STROMPI 3

Productinformation Rev. 1.1

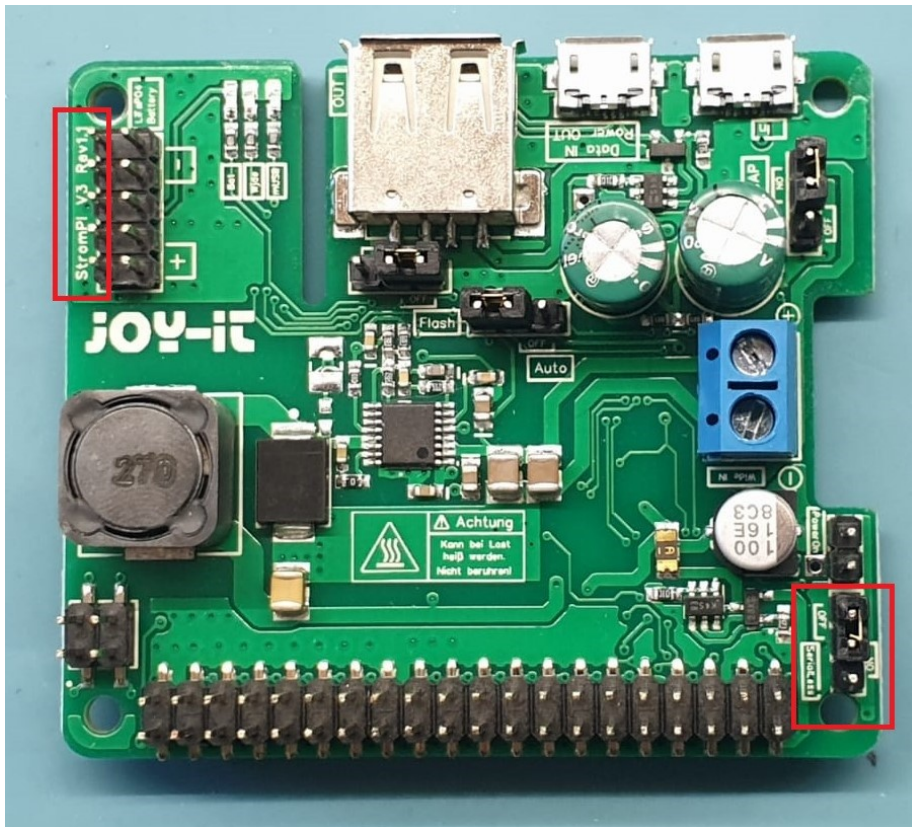
The revision 1.1 of the StromPi 3 can be recognized by the inscription "StromPi V3 Rev1.1" near the connector for the BatteryHAT and by the additional serialless jumper near the 40 pin GPIO connector.

In revision 1.1 the modifications, which had to be soldered in revision 1, have been incorporated into the PCB design. This means that **soldering is no longer necessary** for the PowerOn button function and for the serialless function.

The newly added serialless jumper connects the GPIO 21 (pin 40) of the Raspberry Pi to a GPIO of the microcontroller when set to "ON". The serialless function must still be activated as usual in the configuration of the StromPi 3.
